PROPOSED LAY OUT PLAN OF INDUSTRIAL AREA SHILPGRAM AT JAISALMER. (RAJASTHAN)

DRG. NO. IPI/ 201/ 92 DT = 16.09.1992

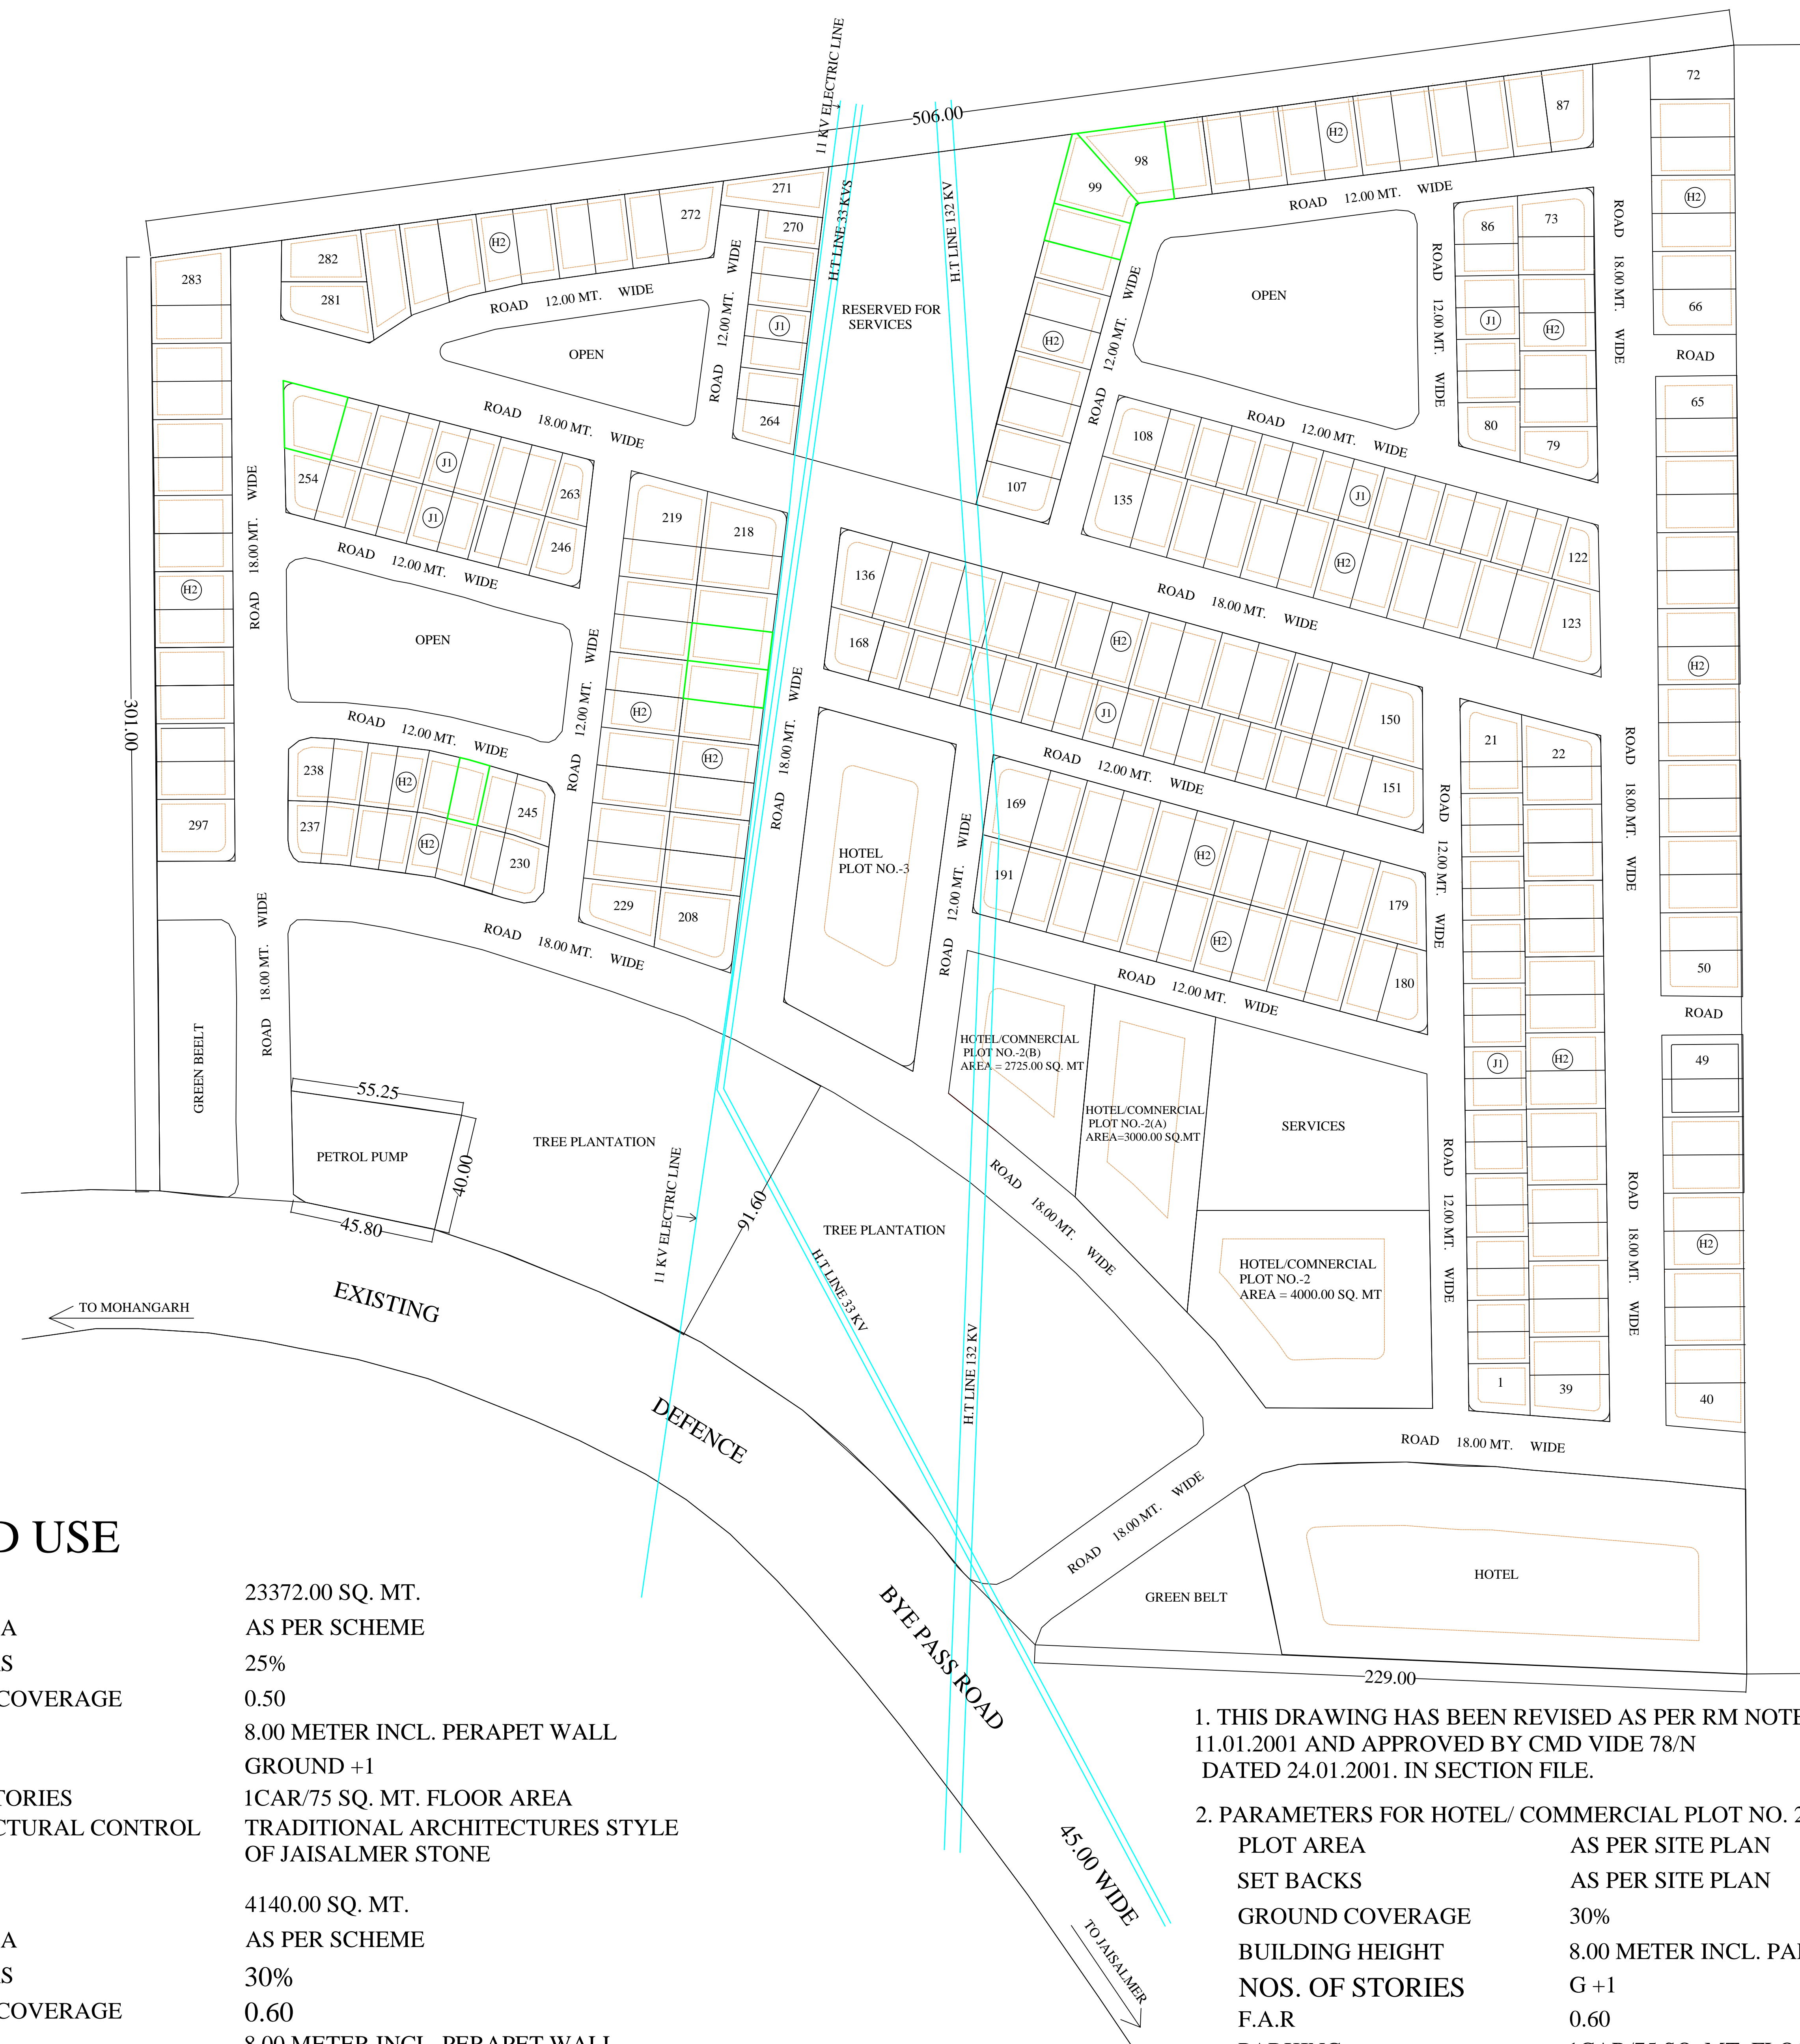
THIS REVISION HAS BEEN MADE AS PER RM LETTE NO. 3631 DATED 30.08.2000 AND APPROVED BY CMD VIDE 44/N DATED 14.09.2000. IN SEC. FILE.
THE REVISED PORTION (GENERAL ZONE) SHOWN THUS.

1. THIS DRAWING HAS BEEN REVISED AS PER RM NOTE ON DATED 11.01.2001 AND APPROVED BY CMD VIDE 78/N DATED 24.01.2001. IN SECTION FILE.

2. PARAMETERS FOR HOTEL/ COMMERCIAL PLOT NO. 2, 2A & 2B
PLOT AREA AS PER SITE PLAN
SET BACKS AS PER SITE PLAN
GROUND COVERAGE 30%
BUILDING HEIGHT 8.00 METER INCL. PARAPET WALL
NOS. OF STORIES G +1
F.A.R 0.60
PARKING 1CAR/75 SQ. MT. FLOOR AREA
ARCHITECTURAL CONTROL TRADITIONAL ARCHITECTURES STYLE OF JAISALMER STONE

3. PLOT NO. H2-192 TO H2-207 HAS BEEN DELETED.
4. REVISED PORTION SHOWN THUS. SD/- 25.01.01
DY. TOWN PLANNER
